Independent Electricity Market Operator (IMO)

Connection Assessment

**Temporary Generation Resources in
Ontario for the Summer/Autumn 2003**

Final Report

Figure 2

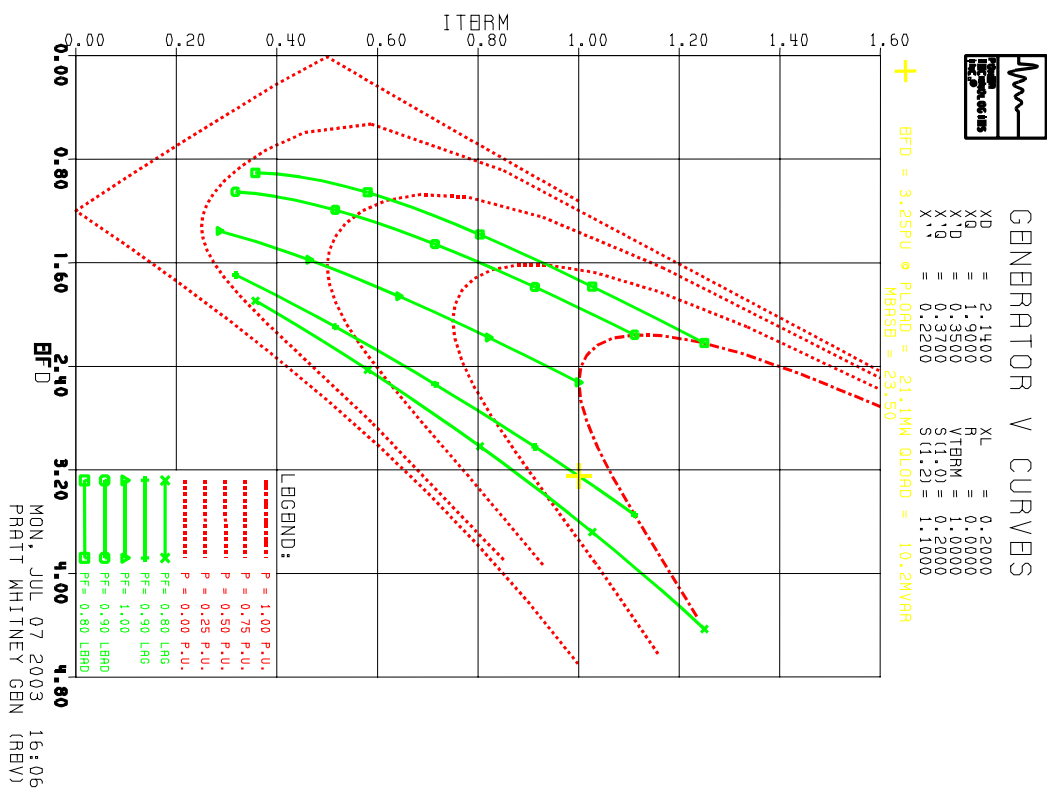
Accordingly, the generator reactance and saturation parameters were revised to get a reasonable agreement with the designed values for short circuit ratio and generator field voltage, Efd, at rated output of the machine. Table 1 also shows the revised values for generator dynamic parameters and the corresponding V-curves are shown in Figure 2.

Figure 6

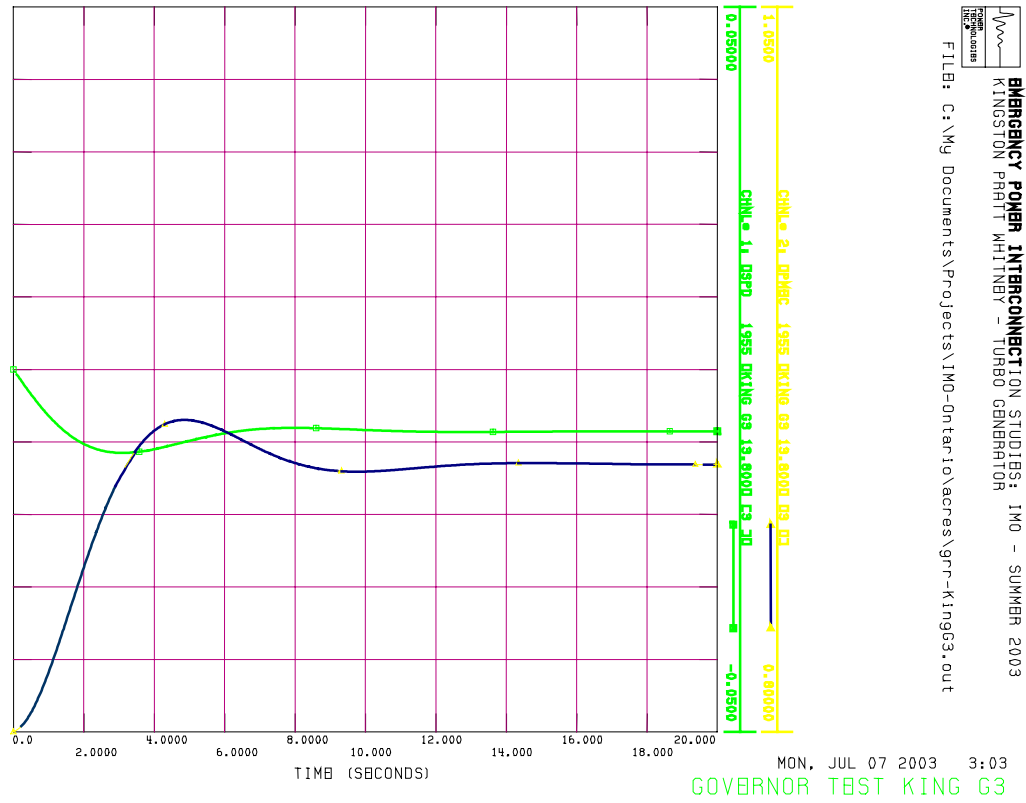
Governor response test was performed using GSTR command in the dynamics module of PSS/E. GAST model with conservative parameters was tested for its response. The machine was initialized at 0.8 pu load for the preparation of the test where the electrical load was suddenly increased to 90% of the unit rating. The results of this test are shown in Figure 6, which confirm that the response with the assumed data is satisfactory.

Figure 5.1.2a: “Markham Cluster” System Diagram Before Generation Addition

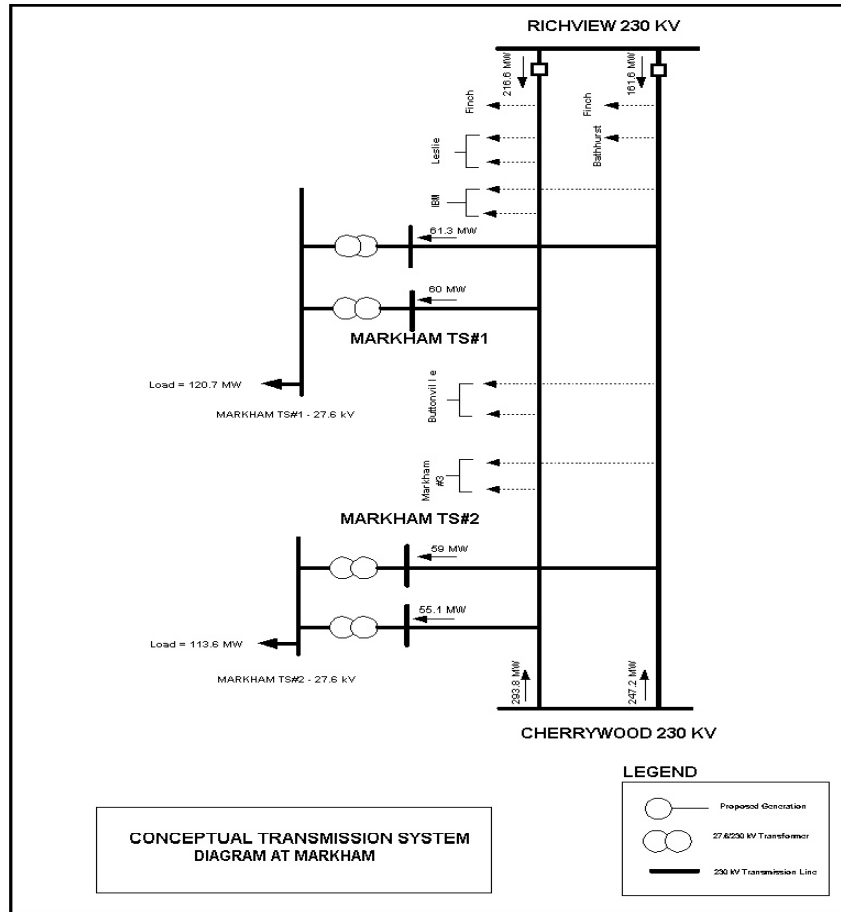
The load flow studies have been carried assuming all the generation connected to TS#1 and TS#2 substations is operating in order to simulate the maximum possible impact of these projects on the transmission system. A conceptual diagram of the system modeled in load flow studies is shown in Figure 5.1.2a

Figure 5.1.2b: “Markham Cluster” System Diagram After Generation Addition

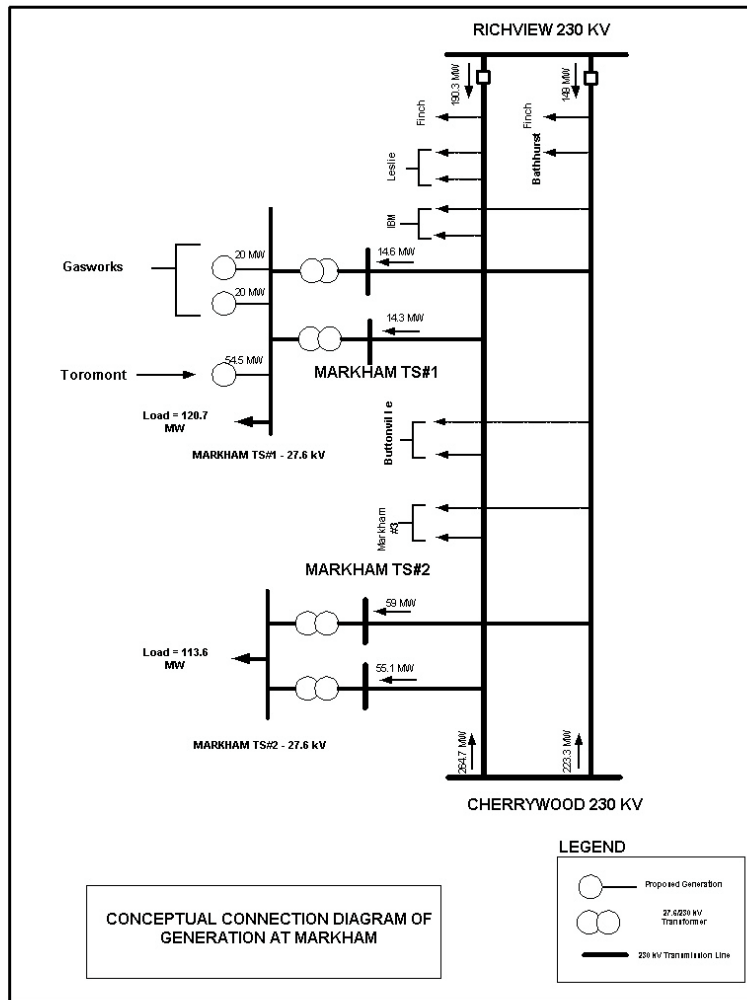
The addition of the 94.5 MW of embedded generation power will result in a reduction in the power flowing over the Cherrywood – Richview 230 kV circuits C11R and C12R to which Markham TS#1 is connected. Load flow study results are shown in Figure 5.1.2b.

Figure 5.3.1a: Kingston Co-Gen Connection Diagram (Assumed)

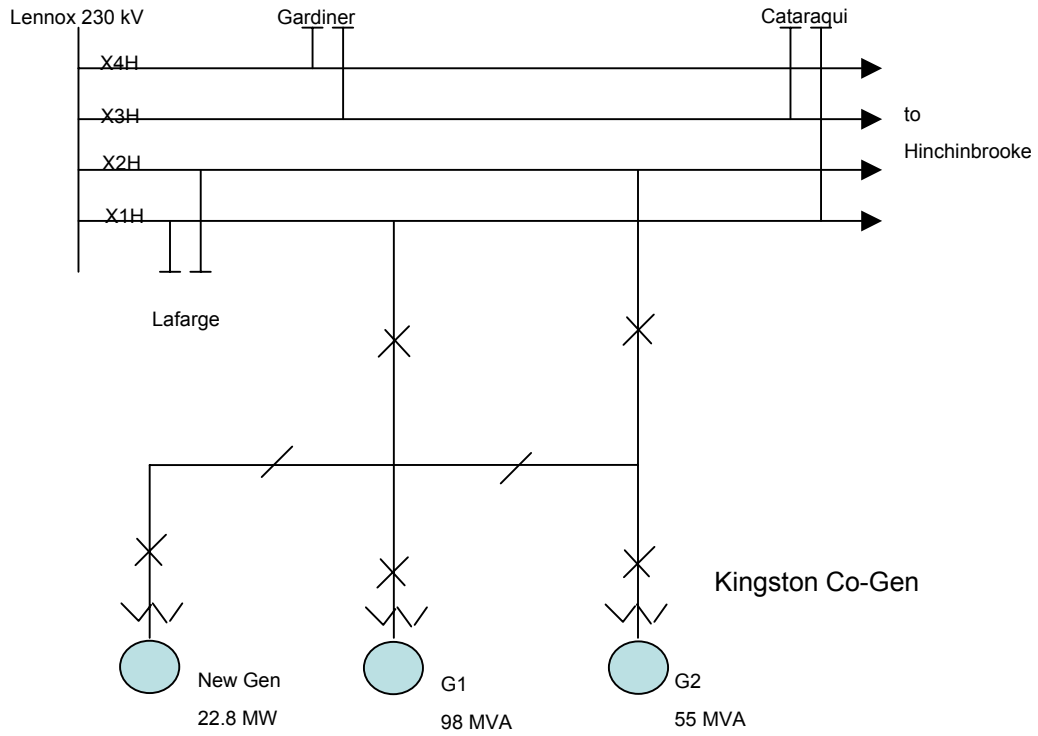
The KCLP proposal is to install 22.8 MW of temporary generating capacity at its existing 110 MW combined-cycle generating plant near Kingston, Ontario. The new generating capacity will be derived from a portable GE TM 2500 generating system operating at 13.8 kV. The new generator will be connected to the IMO-controlled grid at an existing 230 kV bus in the KCLP plant via a 13.8/230 kV 25 MVA transformer and a 230 kV circuit breaker. That bus is currently used to connect the existing 98 MW G1 generating unit and the line tap to 230 kV circuit X1H. The proposed single line arrangement is shown in Figure 5.3.1a.

The proponent did not provide with this application other relevant information related to the connection facilities, such the impedances, tap ratios and winding configurations of the step-up transformers and the ratings of the 230kV circuit breakers.

Figure 5.3.1b: Kingston Co-Gen Governor Response Test Results

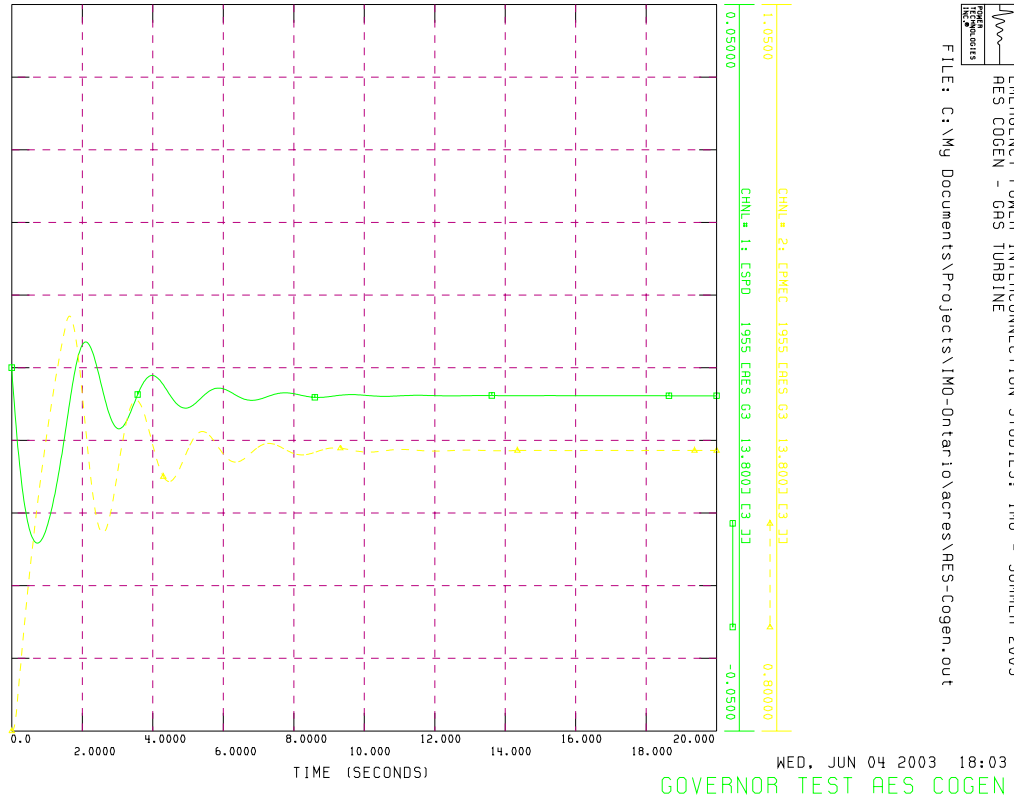
Dynamic simulations were performed with this model to verify the transient response of the governor in isolation of the rest of the system, to a load change of 10%. The results are shown in Figure 5.3.1b and indicate that the governor response as modeled is well damped. Based on this test, the response performance of the governor system of this new unit meets the requirements of the Market Rules.

Figure 5.3.1c: Kingston Co-Gen GAST Governor Model

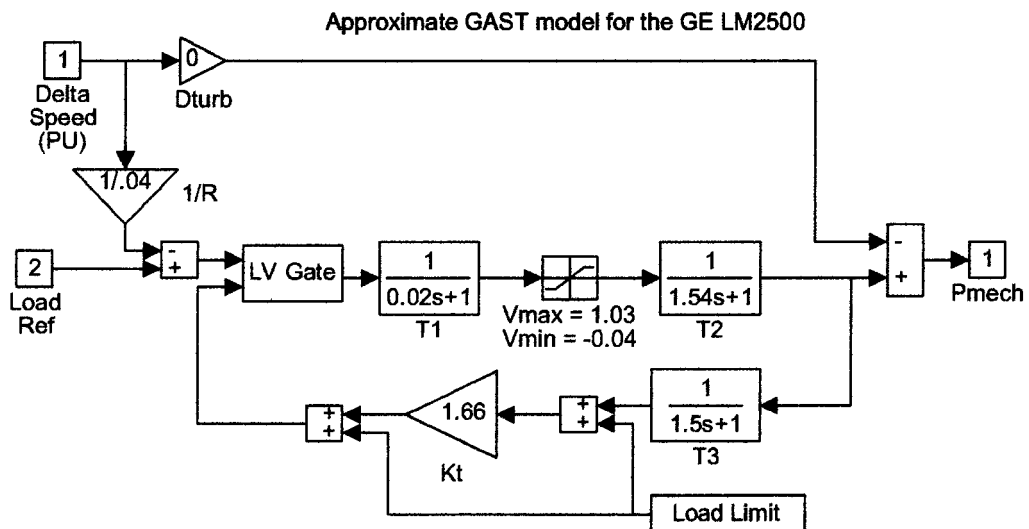
The governor model for the new generator provided by the proponent is shown in Figure 5.3.1c. The governor droop for the Kingston Co-Gen new unit based on the information provided is set to 4%.

Figure 5.3.1d Kingston Co-Gen Exciter Response Test Results

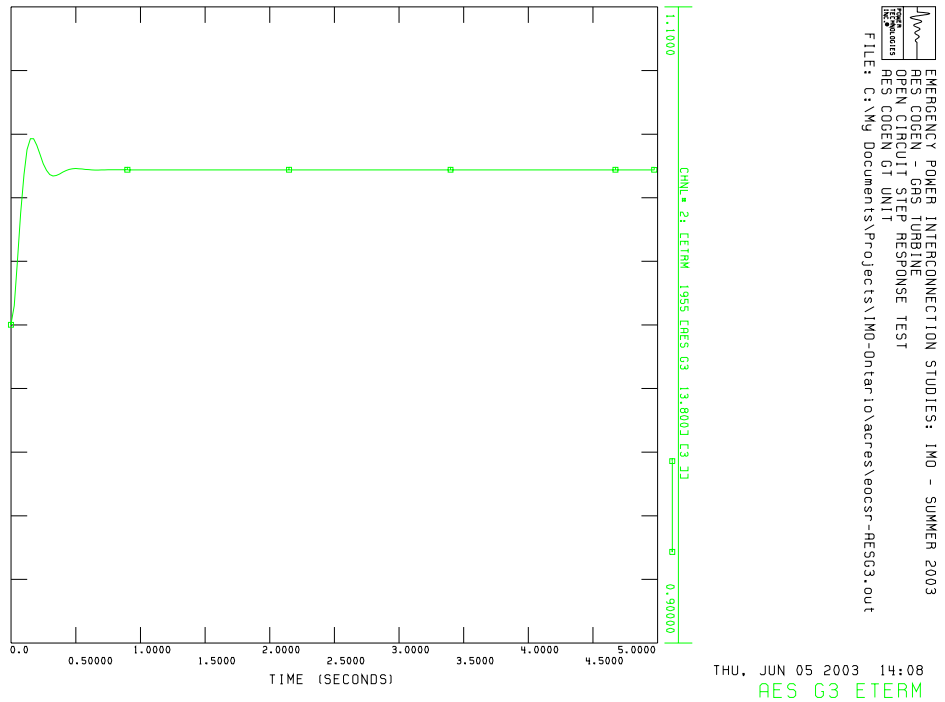
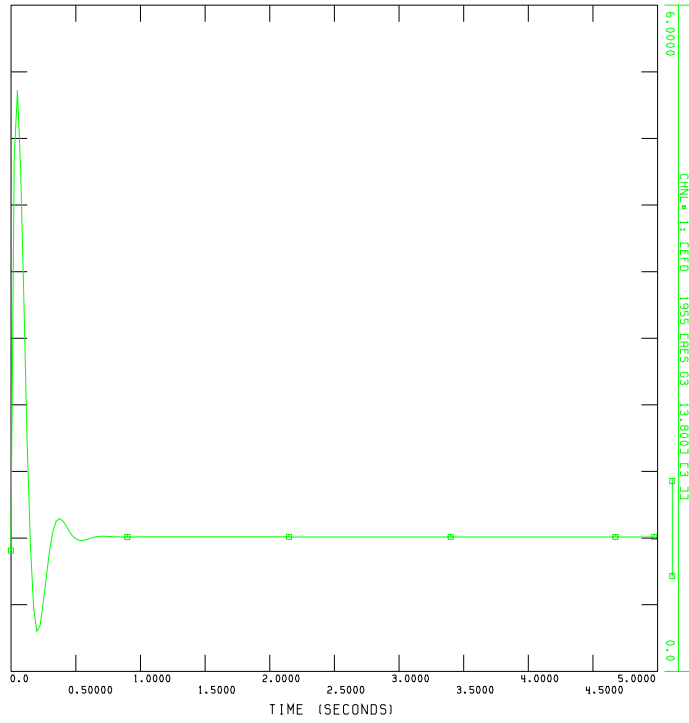
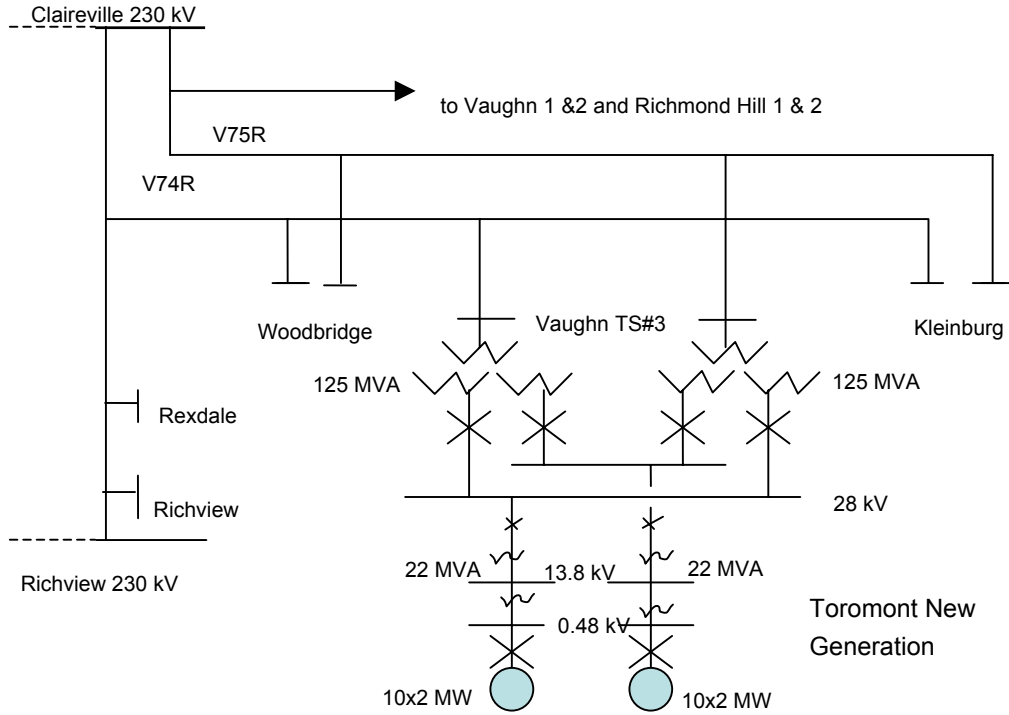
Information on the excitation model used by the new generator was not provided by the proponent. A response test for the excitation system was conducted assuming that the new generator would have the same type of exciter models (EXST1) as the existing G2 unit at the KCLP Kingston plant. The results of that test are shown in Figure 5.3.1d. Performance was shown to be adequate. If the new generator is to have exciter models greatly different from that assumed, than its performance will have to be re-verified.

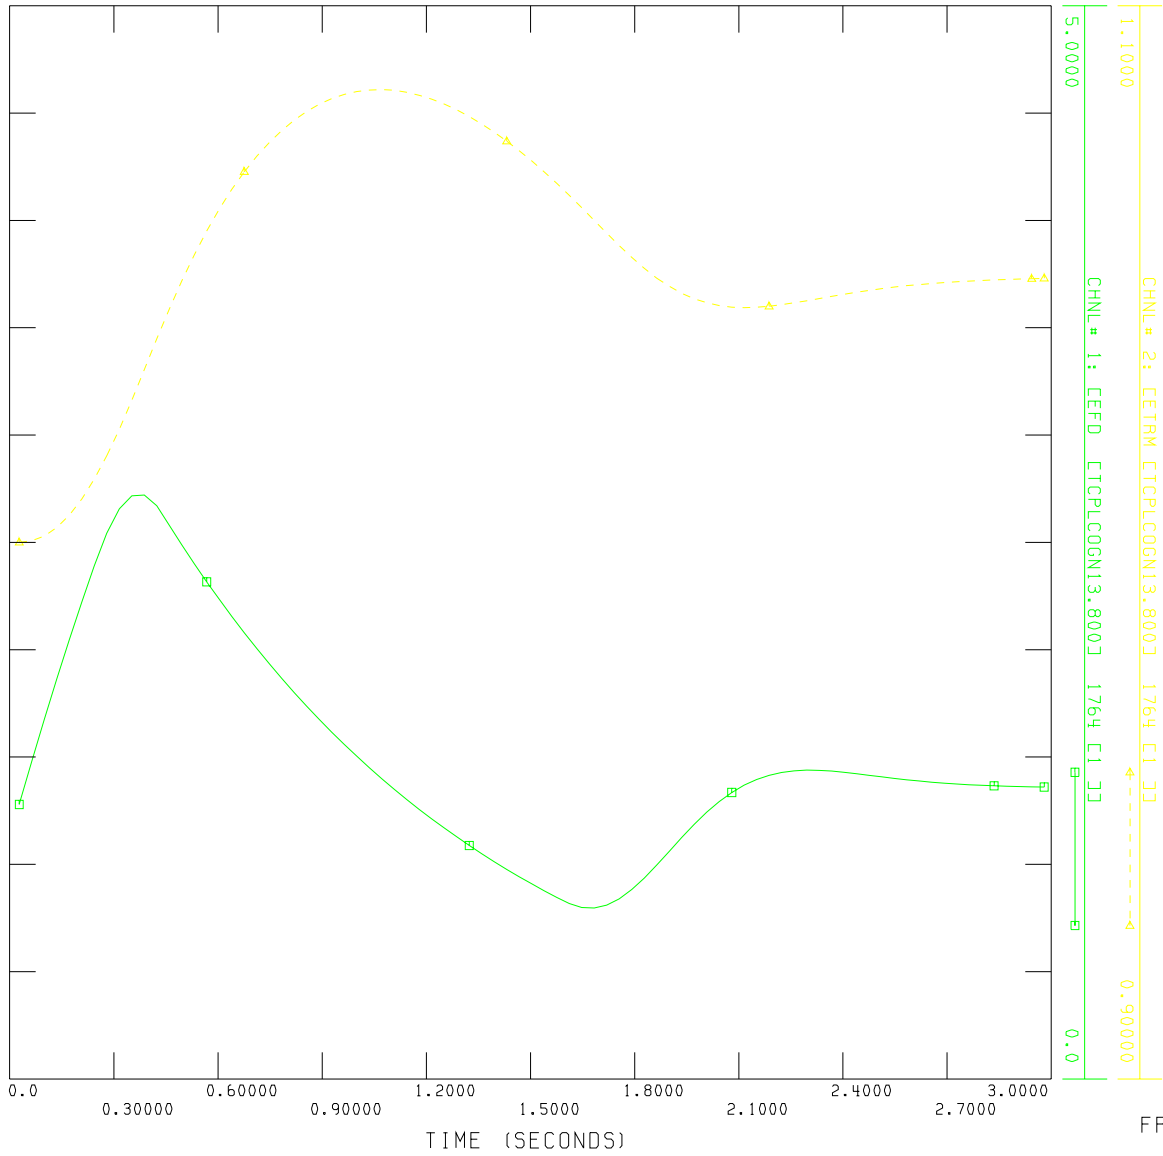
Dynamic simulations were performed with the excitation model shown in Appendix II. The results show that the exciter, as modeled, did not meet the Market Rules requirements for speed of response. The excitation test response curves are also included in Appendix II.

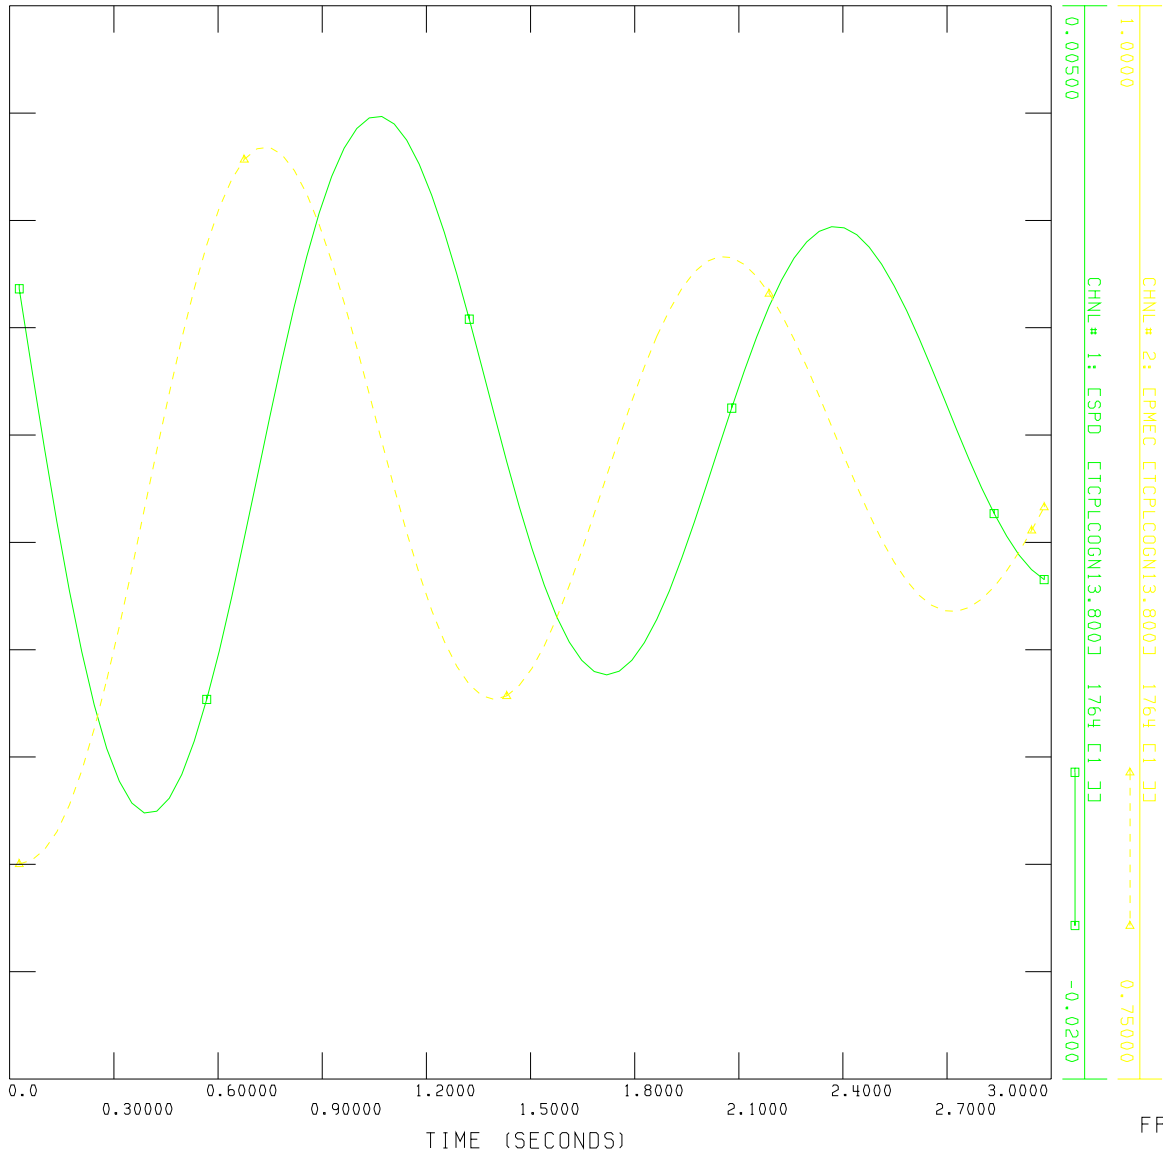
Dynamic simulations were performed with the governor model shown in Appendix II. The results show that the governor, as modeled, produced noticeable oscillatory response for a 20% load change test. The governor test response curves are also included in Appendix II. Tuning of the control parameters will be required to improve damping.
